PEER REVIEW REPORT

Lower East Coast subRegional Groundwater Flow Model and Draft Model Documentation

South Florida Water Management District

June 7, 2006

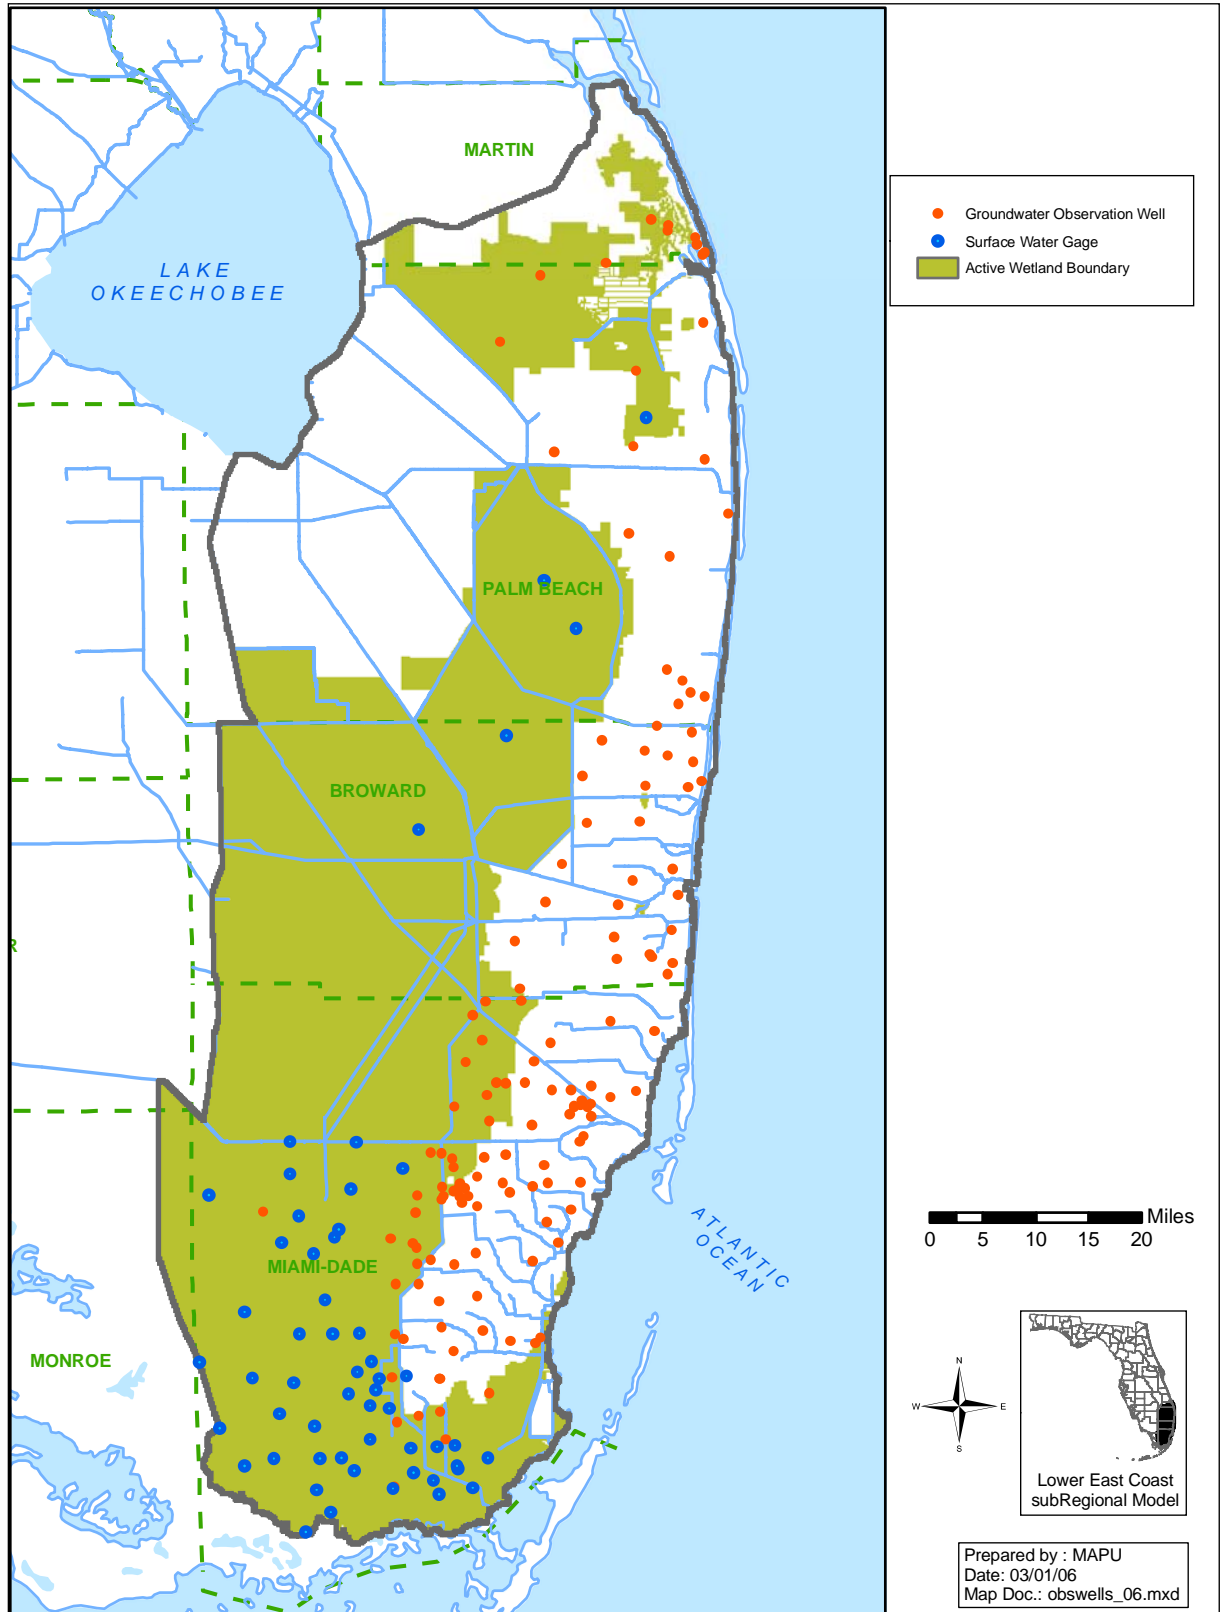
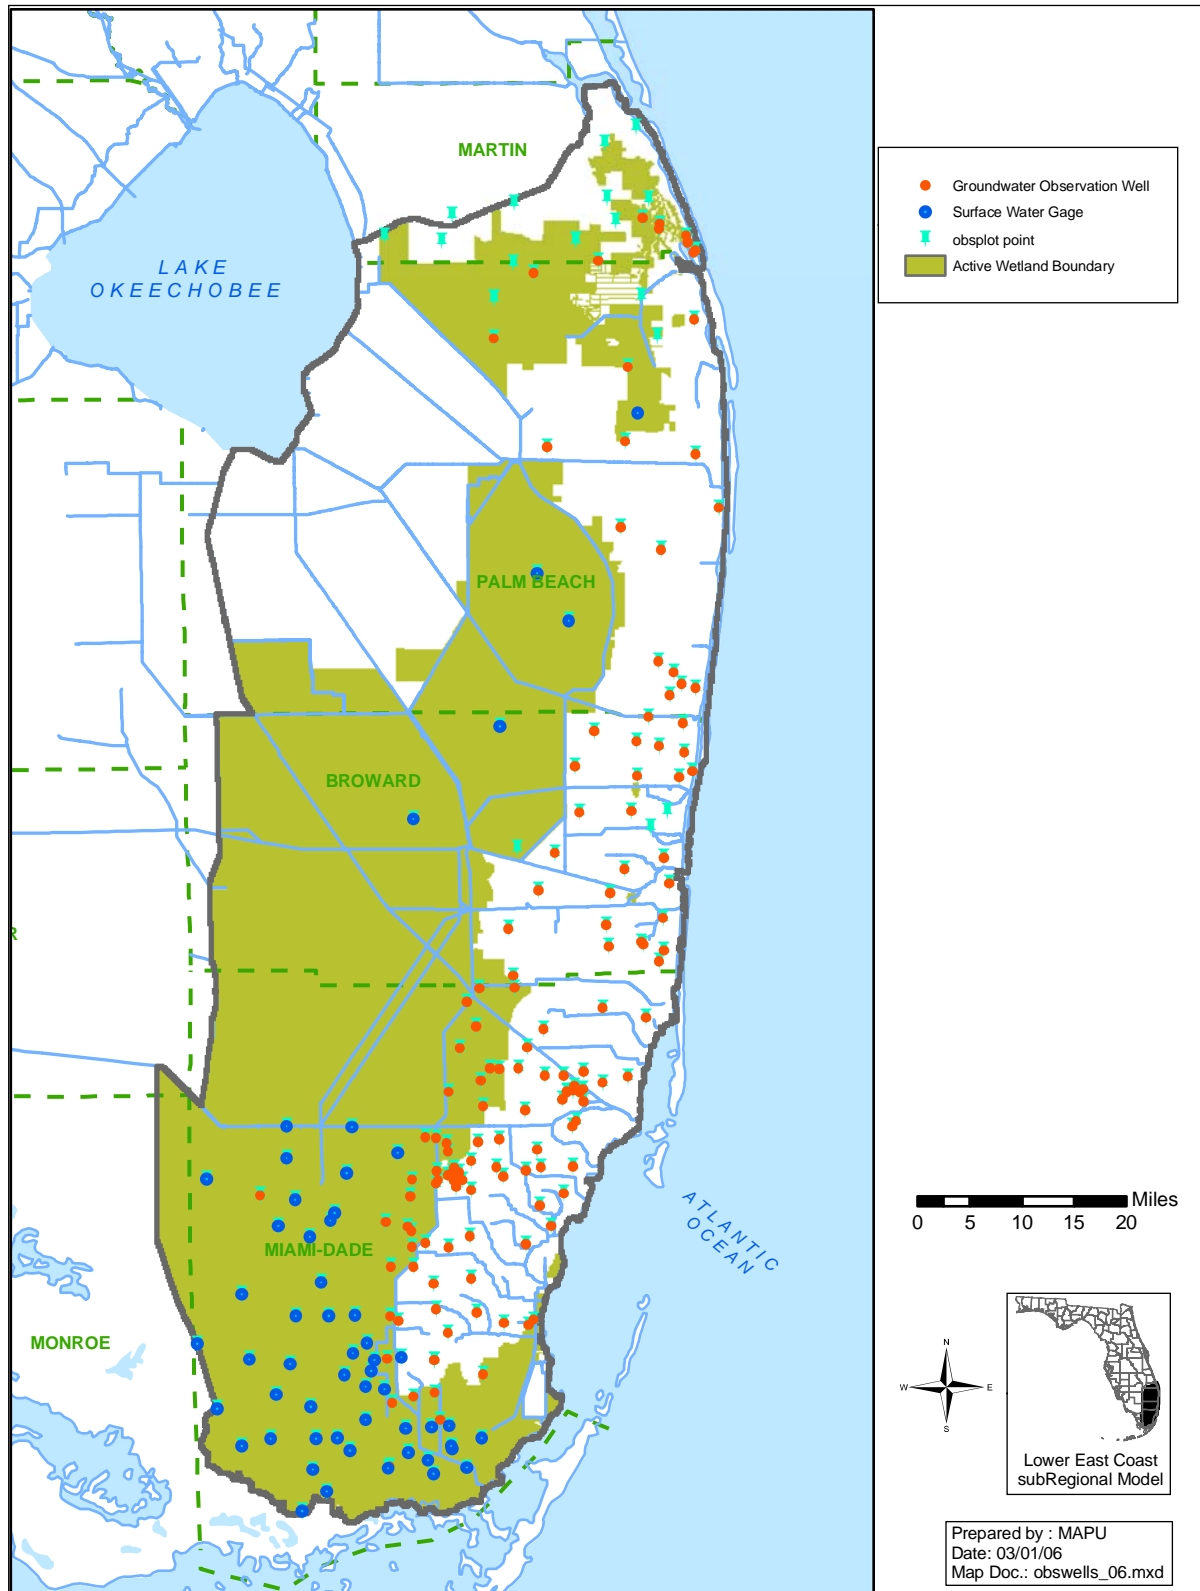
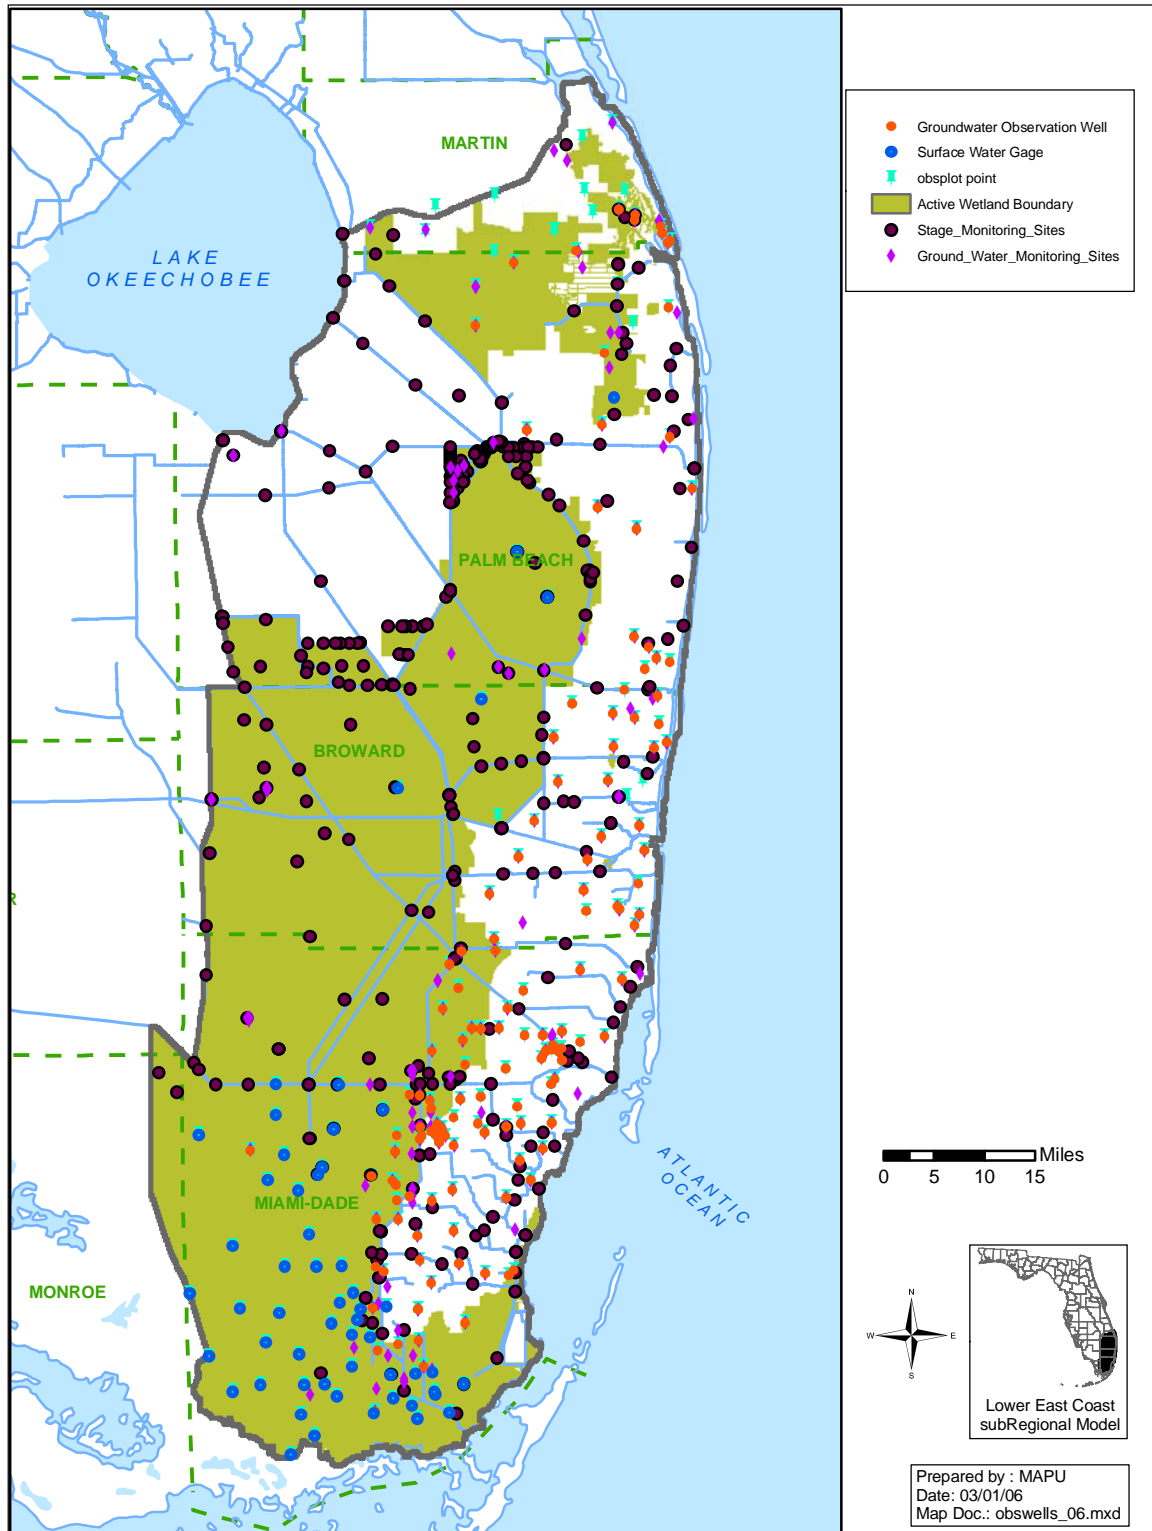
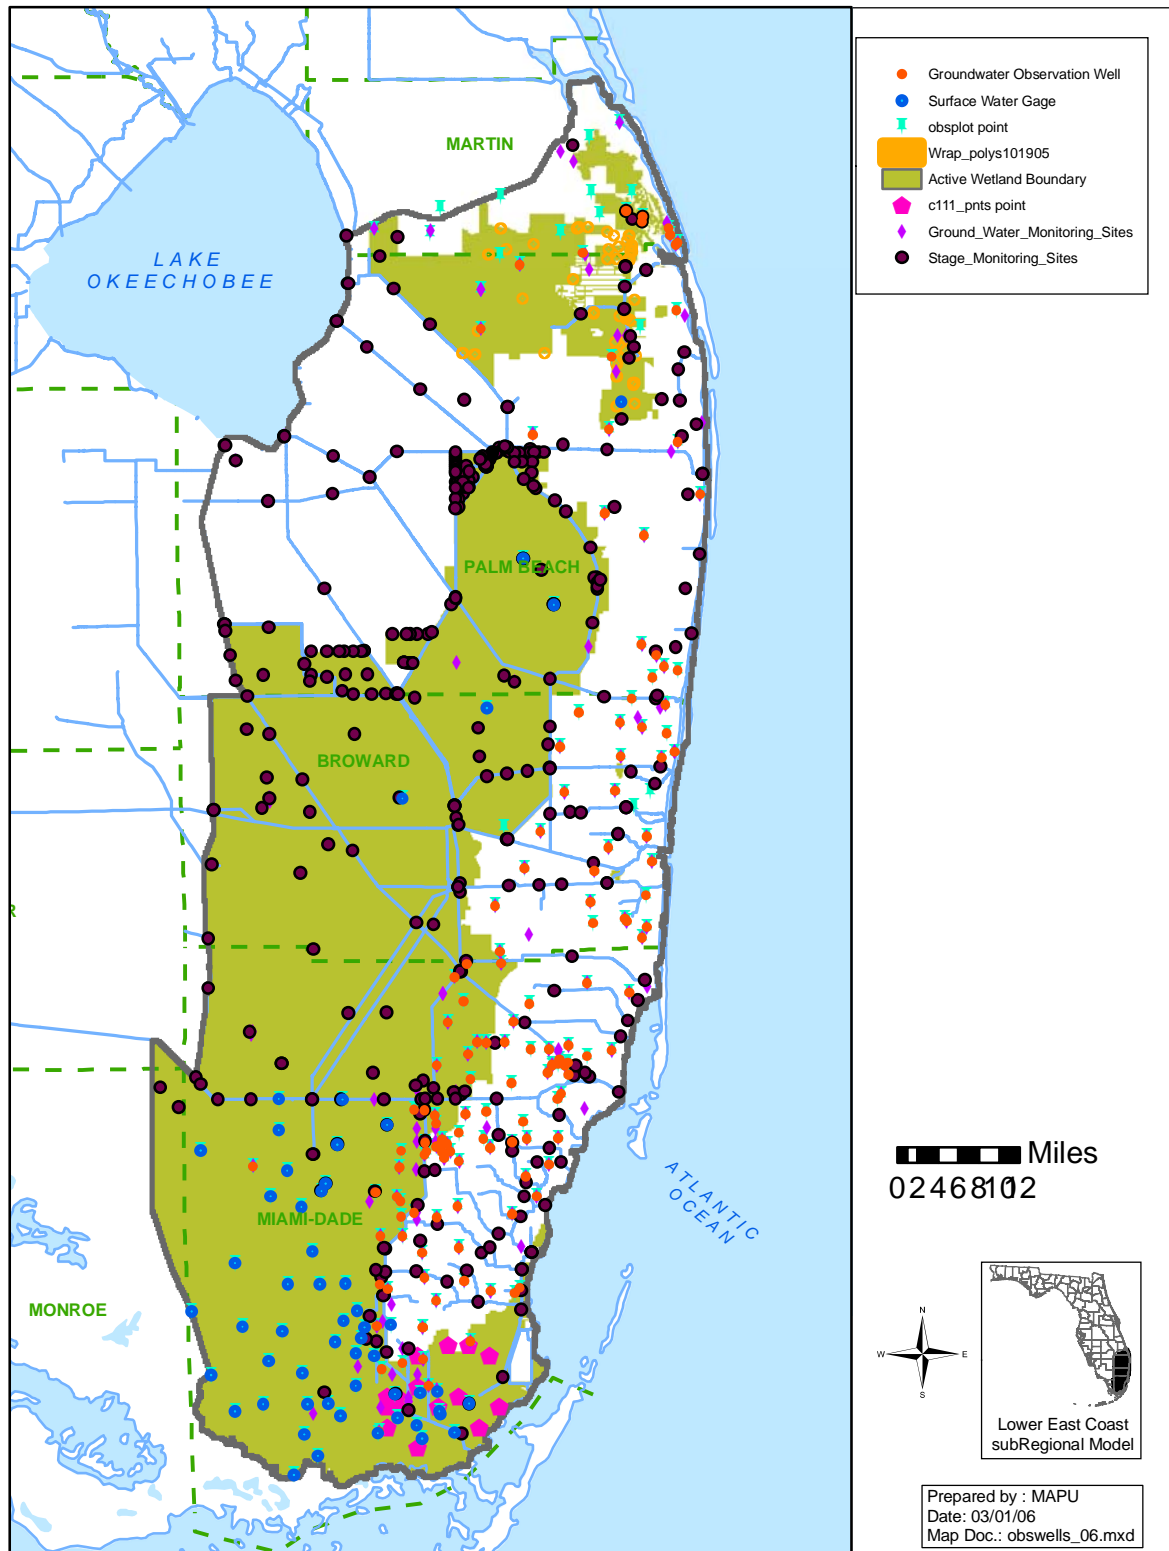
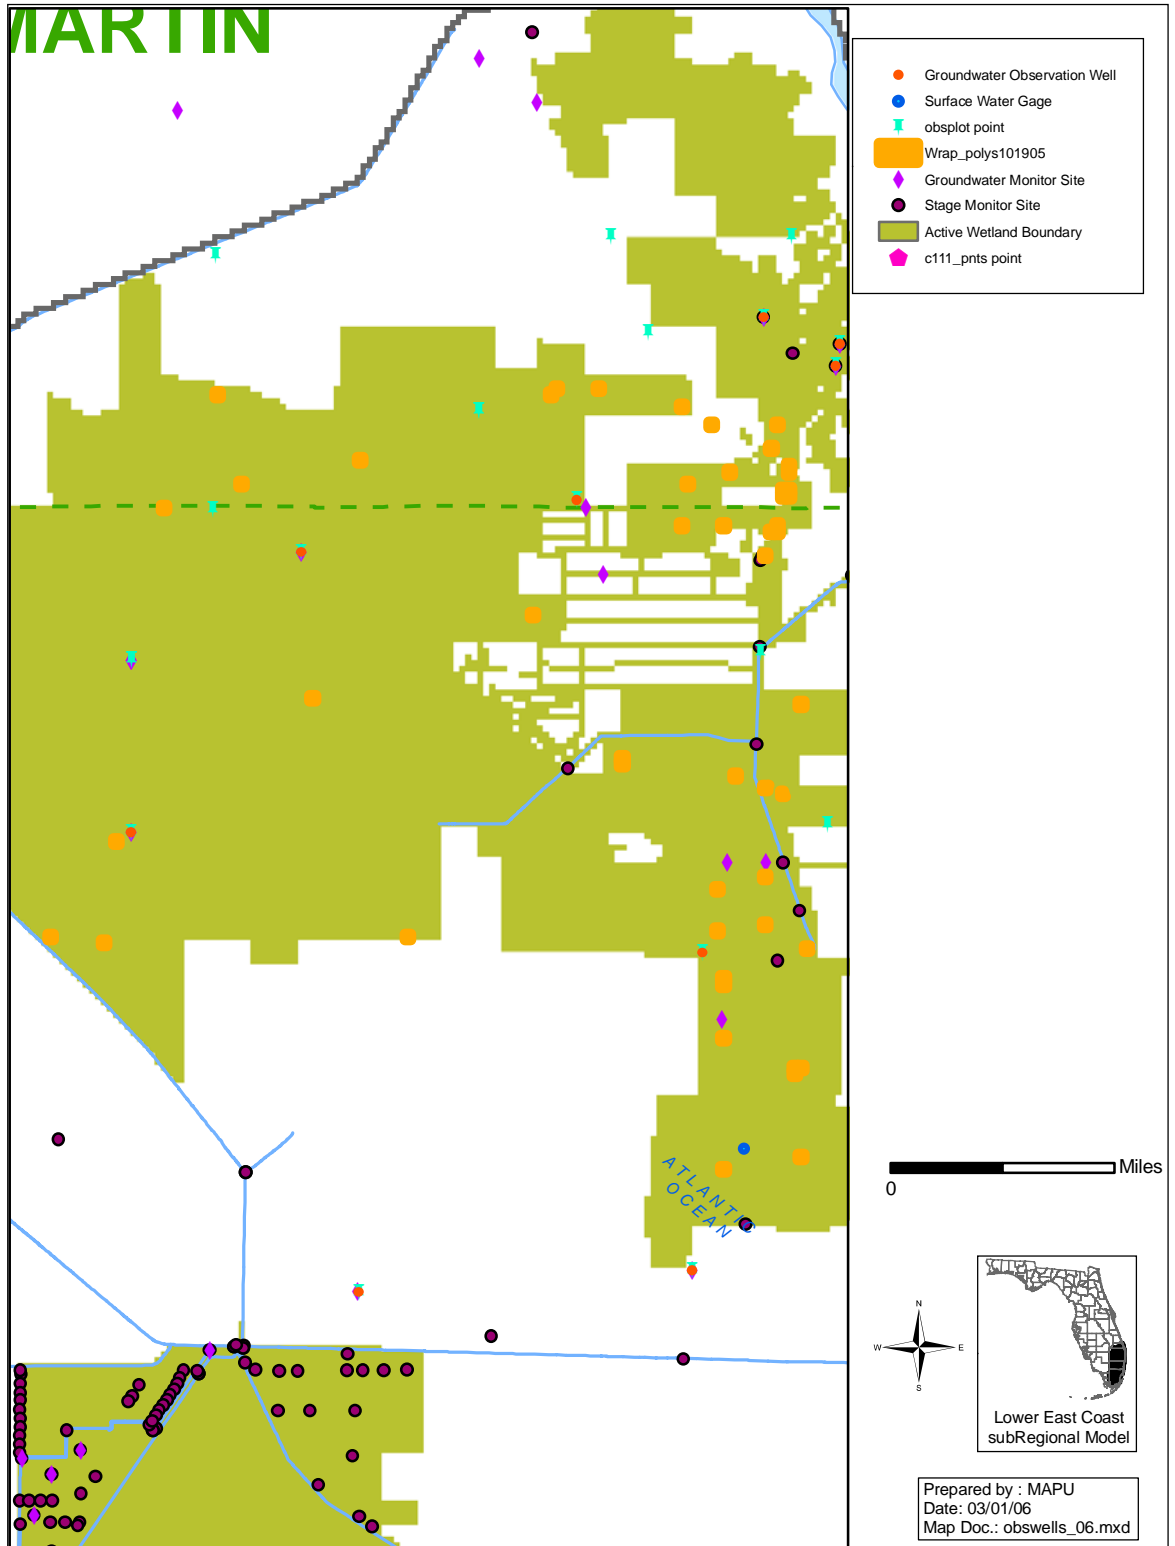
Comment / Question 202: Figure 78 indicates that in large areas of the model domain, particularly in the western half of the model, there are no observation wells or surface water gauges on which to base the quality of model calibration or to influence model calibration. How does the SFWMD address the non-uniform spatial distribution of model calibration target points? While the "global" criteria appear to be pretty well met, the spatial variability in target well and surface water gauge locations tends to beg the question of how well is the model really calibrated when there is fully half of the domain with no observed data on which to further judge the calibration. If the model is eventually used to address issues in these areas, will the SFWMD have the same level of confidence

in the model output as in areas where the calibration was pegged to a dense spatial distribution of observed measurements? In fact, overall the model could possibly be very sub-optimum (especially in the northern half of the domain) as it appears from Figure 78 that nearly half of all calibration target wells and surface gauges are in Miami-Dade County. The model could be significantly spatially biased due to the lack of uniform spatial coverage of calibration targets. What would be the calibration results if an attempt was made to remove many of the calibration targets in the southern half of the model so that there was more uniform spatial coverage of target wells? Could the overall quality of the model be improved by this exercise?

Response 202: There are a number of additional wells that were not included in the formal calibration. These include wells that are monitored with tape downs on a monthly or quarterly basis. The quality of this data is reasonable for some wells and questionable for other wells. Inclusion of these wells would greatly increase the number of observation wells in portions of Broward, Palm Beach and Martin Counties, particularly within the urban areas. In addition several other surface water gages are available in the Water Conservation Areas which were overlooked in the original data gathering process. The District is hesitant about removing observation wells from the calibration process to attempt to achieve a more uniform spatial coverage. The addition of these monthly or quarterly wells would be more advantageous than the removal of the wells in Miami-Dade County. However, this is a significant task and may require a fair amount of time to achieve. Regarding the EAA, we do not believe there is a single Surficial aquifer monitoring well anywhere within the area. The area is required to maintain Best Management Practices in order to minimize nutrient runoff. They comply with this by managing the water table at specific levels below ground surface. Perhaps a form of soft calibration can be utilized in this area by comparing water levels to the topography to understand the depth below ground surface and how well it compares to what the farms are operating the fields at.
